| Request | - | Text amendment modifying TMC Chapters 743, 1103, 1104, 1107, & 1116 relating to the Downtown Parking Lot Review and Improvement Advisory Committee (DPLRIAC) and surface parking lots in the Downtown and Warehouse Districts. |

**ZONING TEXT AMENDMENT
TOLEDO CITY PLAN COMMISSION**

REF: M-4-23
DATE: May 8, 2025
TIME: 2:00 P.M.

Exhibit “A”

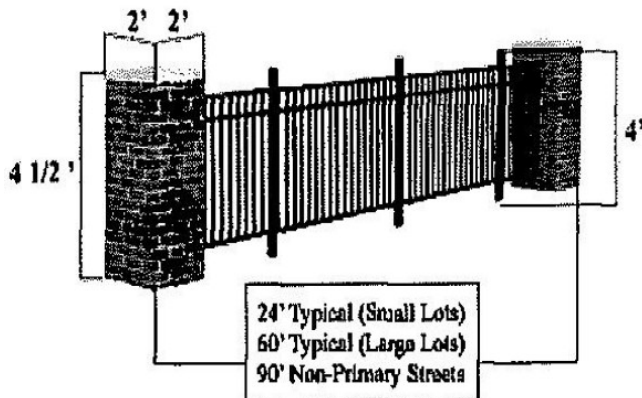
6. Columns may encroach up to 18 inches into the right-of-way subject to the following:
 - a An encroachment permit shall be approved through the Division of Traffic Management.

b Columns shall not interfere with right-of-way pedestrian movement. At a minimum a six foot wide unobstructed walkway shall be maintained within the right-of-way.

Typical Flat Top Design

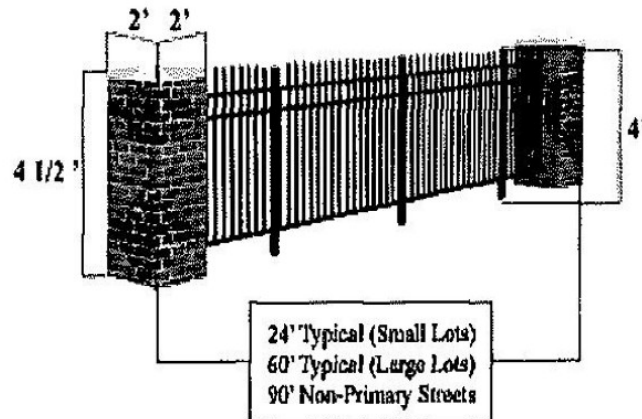
1. ~~a~~ Sections: Standard sections are 6' wide.

2. ~~b~~ Pickets: Commercial 3/4" square x .055

Typical Flat Top Design

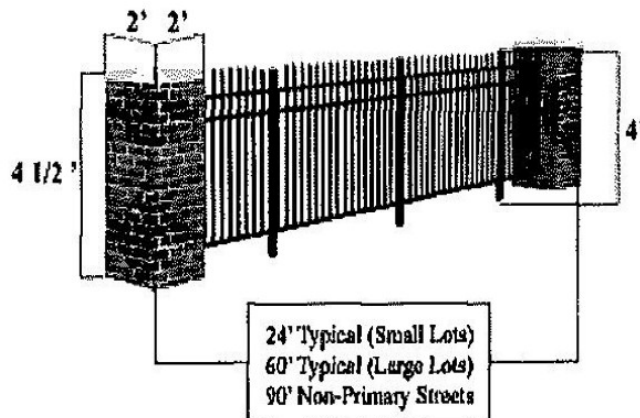
~~1. Sections: Standard sections are 6' wide.~~

- ~~2. Pickets: Commercial $\frac{3}{4}$ " square x .055~~
 - ~~3. Spacing between Pickets: Commercial standard 3-5/8" and optional 1-1/2"~~
 - ~~4. Fasteners: Stainless steel~~
